Number: S.B.QSR 001

SERVICE BULLETIN

Subject: Cracks found on 'H' Frame.

QUASAR SUB-FRAME

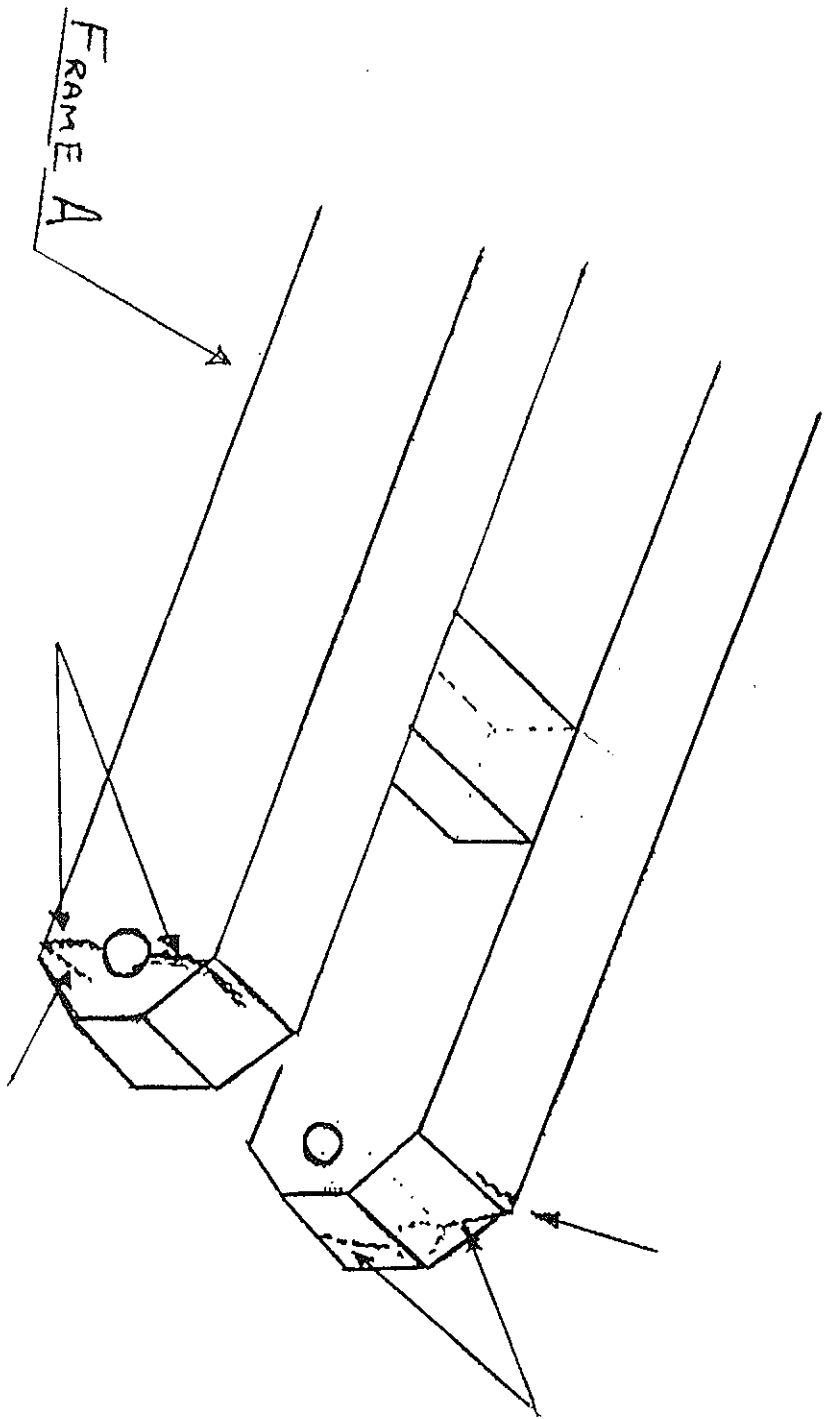
It has been noted that one Quasar has developed cracks on the 'H' frame upper pivot points, radiating from the hinge pin holes (see attached sketch).

CRACKS FOUND ON 'H' FRAME AT THIS POINT
BOTH SIDES

THIS FRAME

CRACKS RADIATING FROM HINGE PIN HOLES BOTH SIDES
AND RUNNING ACROSS BOX SECTION

All operators must inspect for cracks in this area. If any cracks are found, please inform the manufacturer and ensure that the ride is not used until repairs have been carried out.
